Lloyd's Register of Shipping.

Ship's Name "CARROWDORE" Official No. 132047

Memorandum of alterations reported since ship was surveyed for assignment of Load Lines in _____

ALTERATION TO HATCHWAYS NOS 1 & 2.

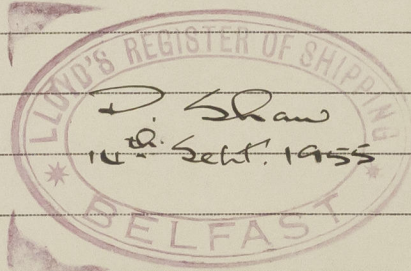
Existing arrangement of single strong beam with wood fore and afters dispensed with and new hatch closing wrgt. fitted as follows.

Nº1	Nº2	
Description of Hatchway	Upper Deck	R.Q. Deck	
Dimensions of Hatchway	29'-6" x 16'-3"	31'-2" x 16'-3"	
COAMINGS	Height above Deck	
	Thickness	Sides	...	
		Ends	...	
	Stiffeners	
	Brackets, Stays	
		NO ALTERATION		
HATCH BEAMS	Number	5	5	
	Spacing	4'-11"	5'-2 1/3"	
	Scantling and Sketch	
	WEB	14 x 34	12 x 30	
	TOP & BOTTOM BARS	3 1/2 x 3 x 42	3 1/2 x 3 x 42	
	Bearing Surface	3"	3"	
FORE AND AFTERS	Number	
	Spacing	
	Unsupported Lengths	
	Scantling* and Sketch	
	Bearing Surface	
HATCH COVERS	Material	W.W.	W.W.	
	Thickness	2 3/8"	2 3/8"	
	How fitted	F & A	F & A	
	Bearing Surface	3 1/2"	3 1/2"	
Spacing of Cleats	...	24"	24"	
Number of Tarpaulins	...	2	2	
*Are wood fore and afters steel shod at all bearing surfaces?				✓
Are battens and wedges efficient and in good condition?				Yes ✓
Are tarpaulins in good condition and in accordance with rule requirements?				Yes ✓
Are lashings provided in accordance with rule requirements?				Yes ✓

Arrangements as approved
See Ship Letter 29/7/55
